**Marty Stuart's Congress of Country Music – Ellis
Theater Renovations**

MECHANICAL/PLUMBING BID PACKAGE

ADDENDUM NO. 4

TO: All Bidders on the Above Referenced Product
FROM: Dryden Architecture + Design
DATE: October 22, 2021
SUBJECT: **ADDENDUM NO. 4**

M-303

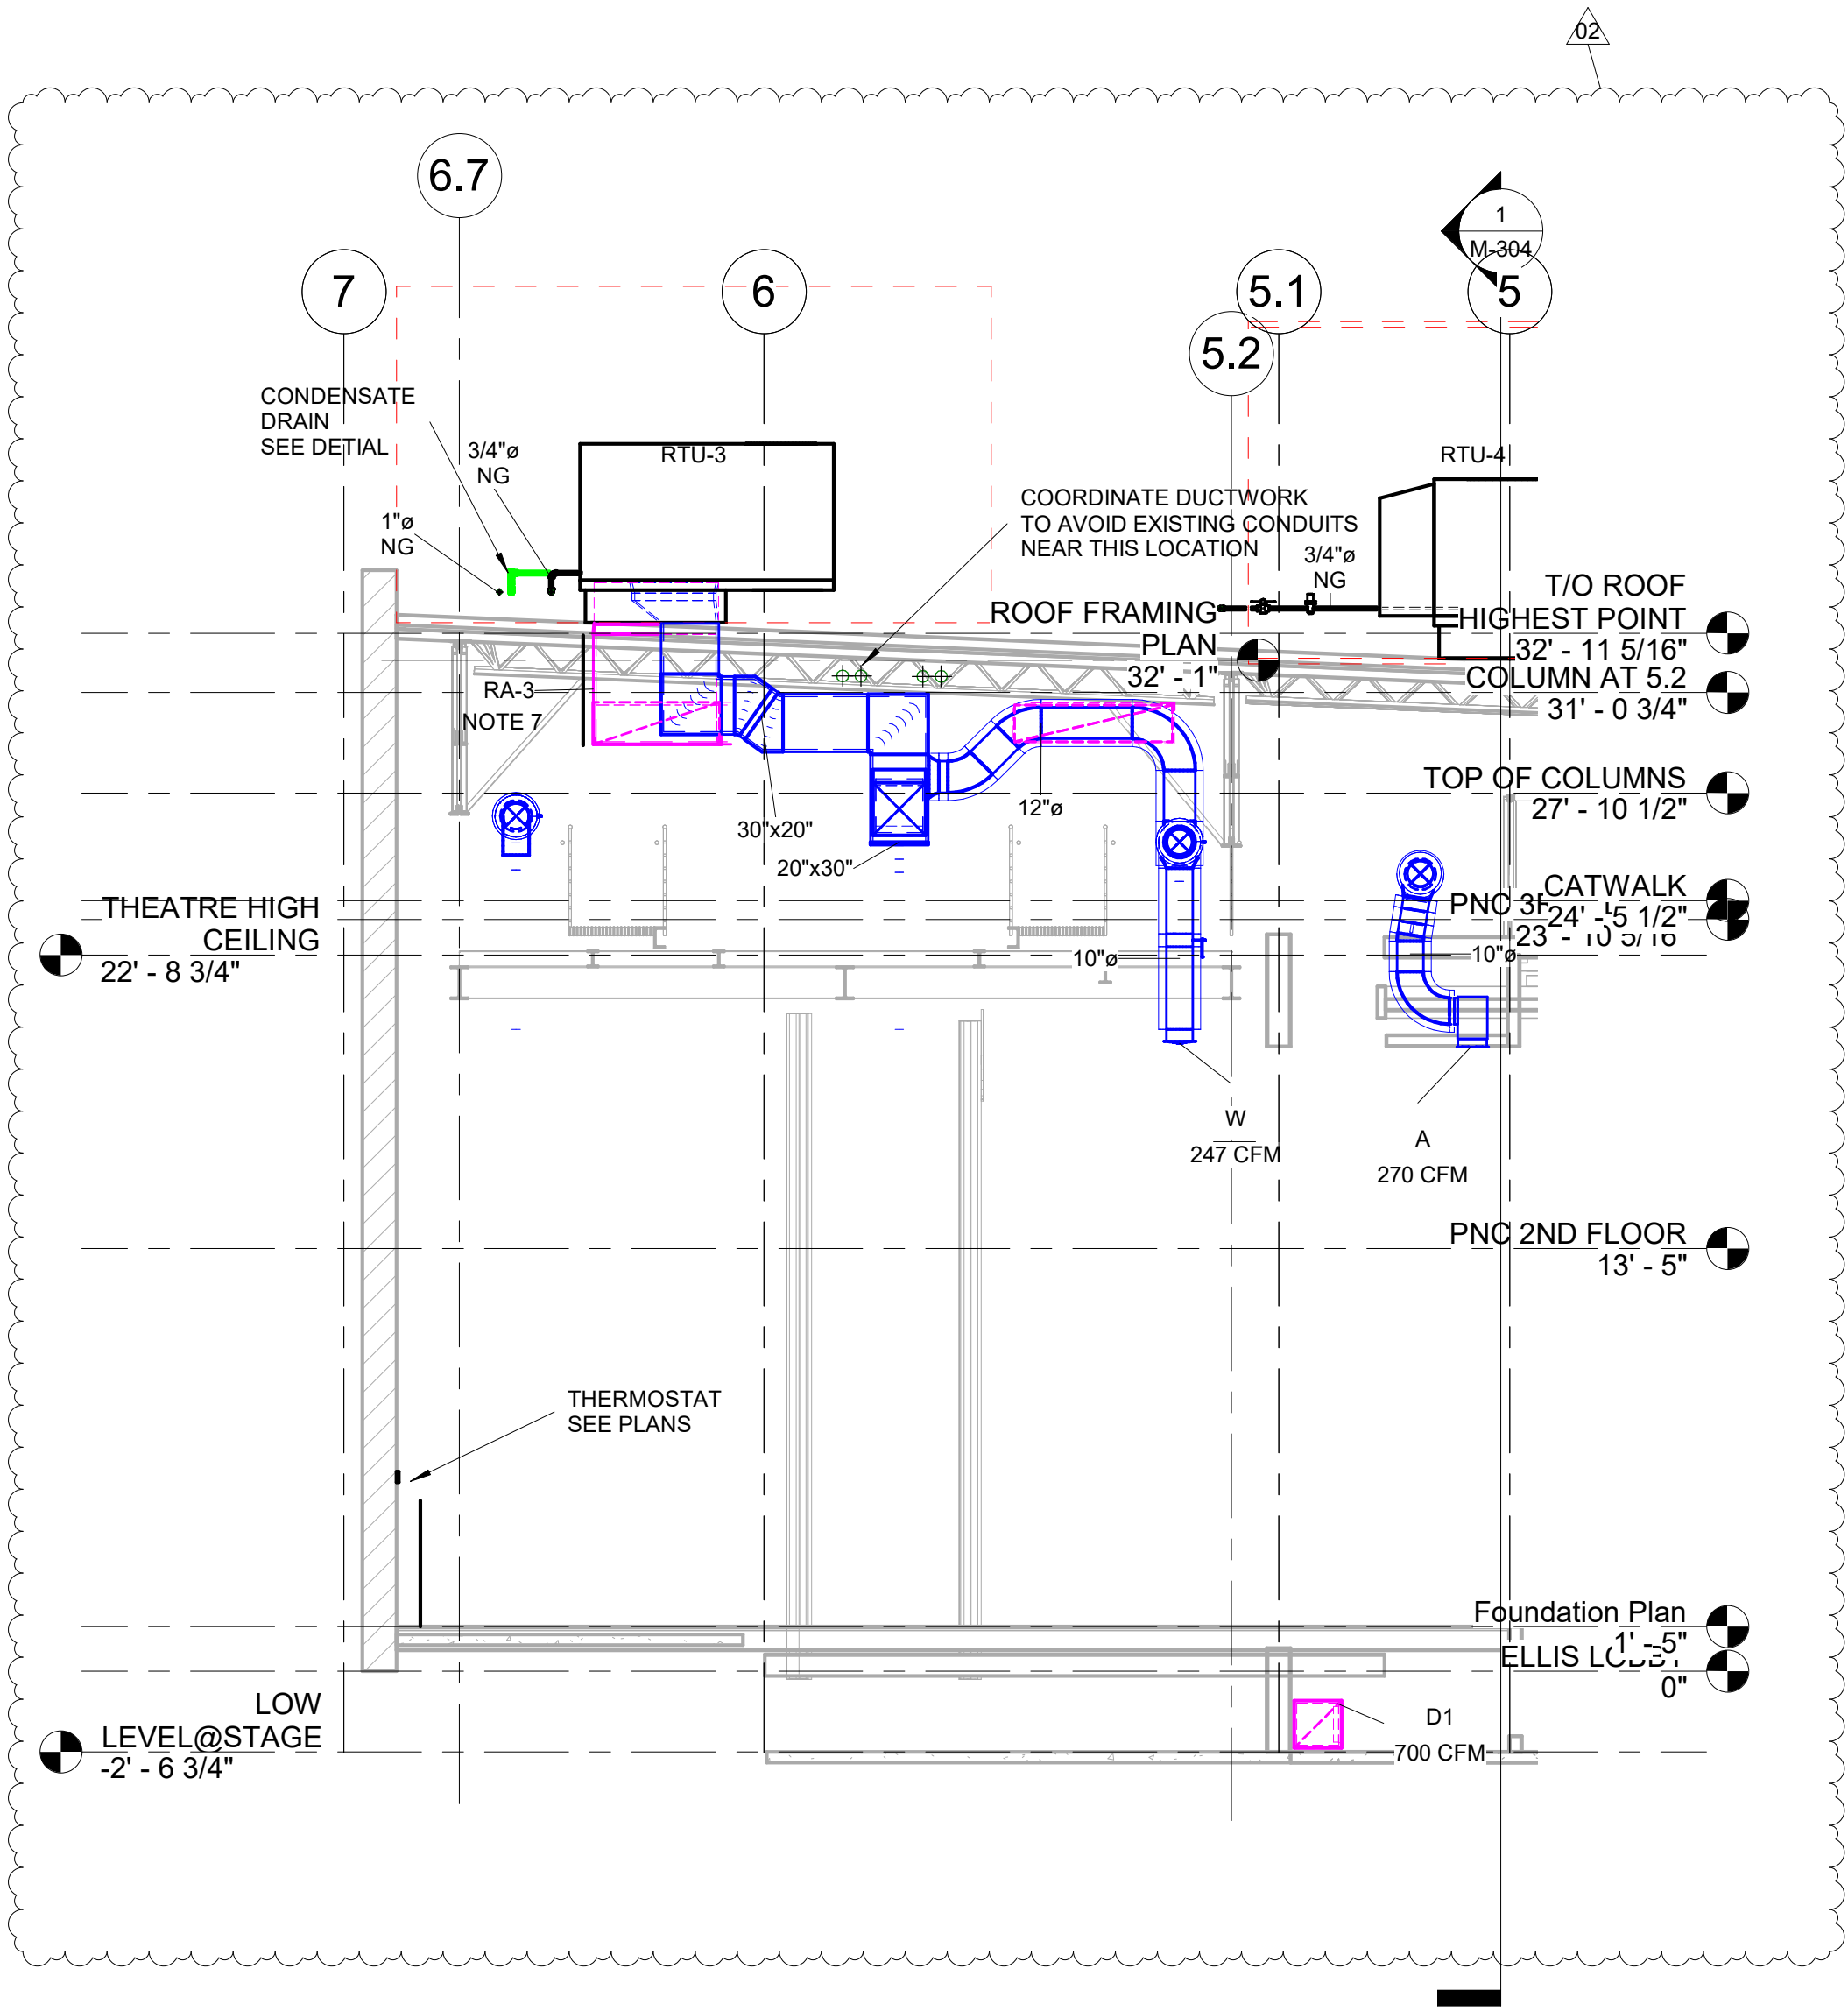
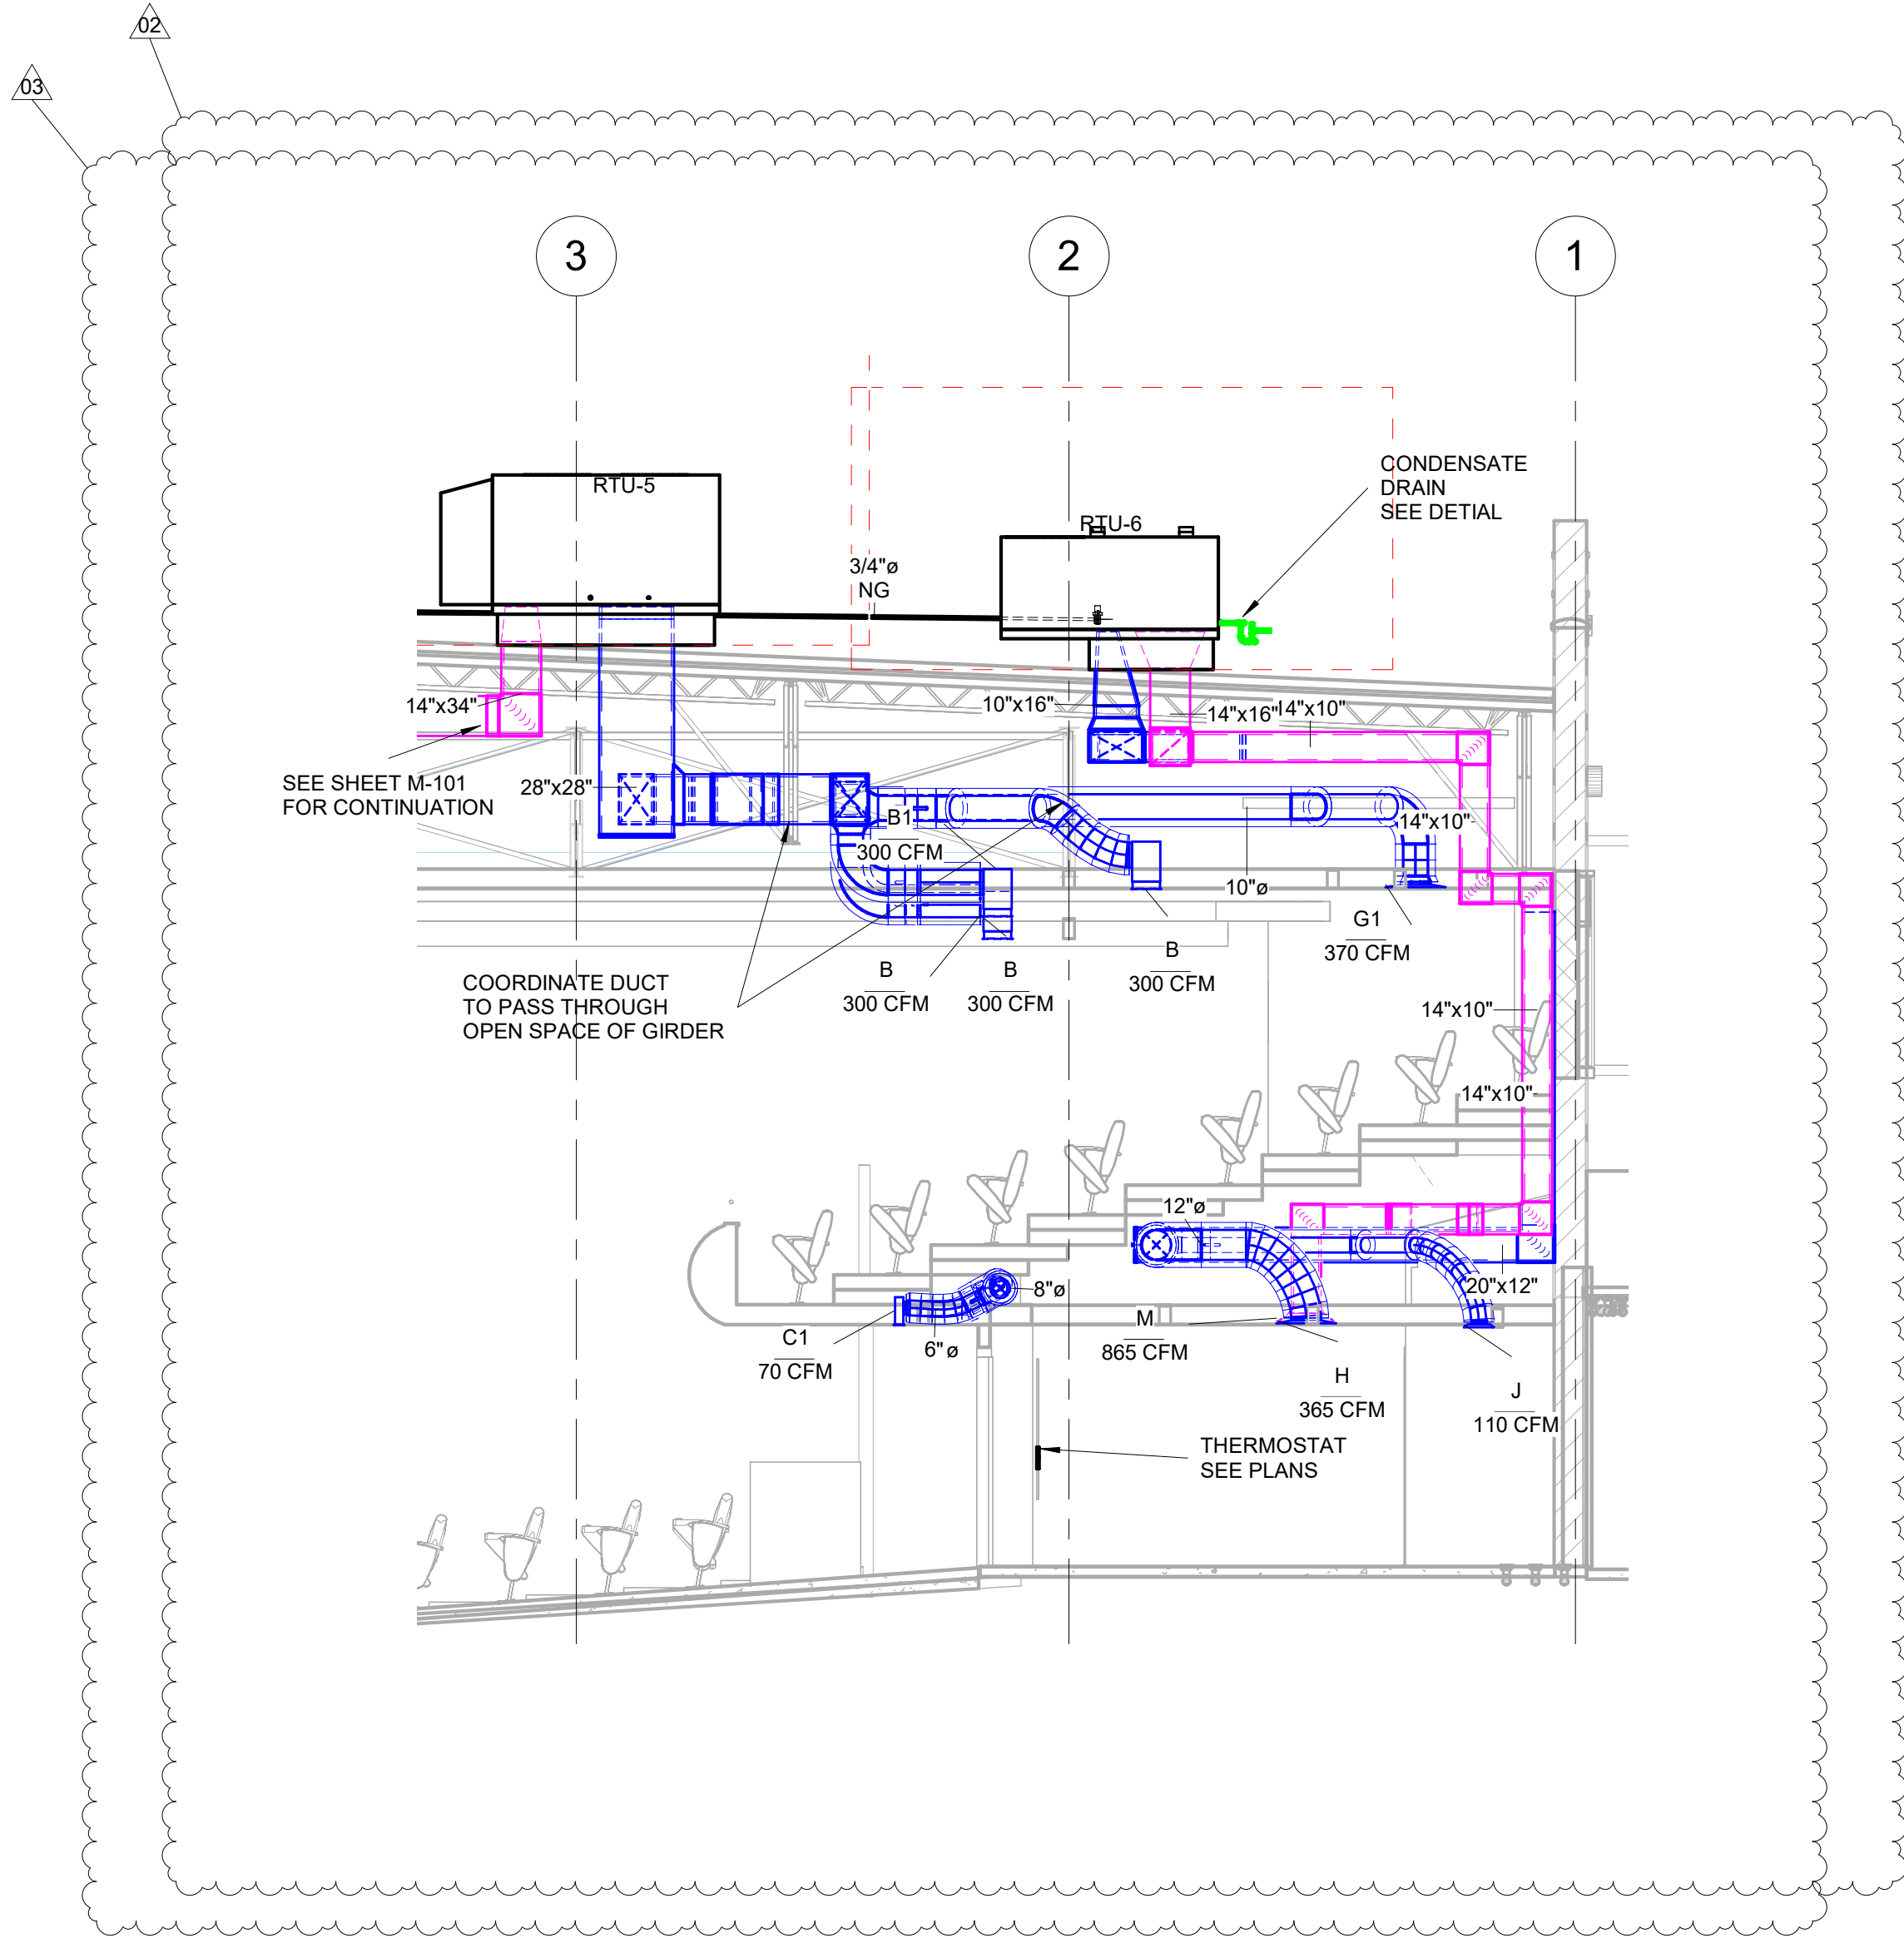
1. **REPLACE:** Specification 00 10 01.1 Advertisement for Bid with Specification 00 10 01.2 (attached)
2. **REPLACE:** Specification 00 20 01.1 Instruction to Bidders with Specification 00 20 01.2 (attached)
3. **REPLACE:** Specification 00 40 03.1 Mechanical/Plumbing Package Bid Form with 00 40 03.2 (attached)
4. **REPLACE:** Original Table of Contents with attached Table of Contents
5. **REPLACE:** Drawing P-102 No. 2 with Drawing P-102 No. 3 (attached) (reroute of domestic and fire water supply)
6. **CLARIFICATION:** Specification 23 74 00
 - a. The requirement for inverter driven or variable speed compressors for the packaged rooftop equipment may be omitted
 - b. Change the modulation hot gas reheat requirement to on-off hot gas reheat
 - c. Change the requirement for single zone VAV fan operation to multi-speed fan operation
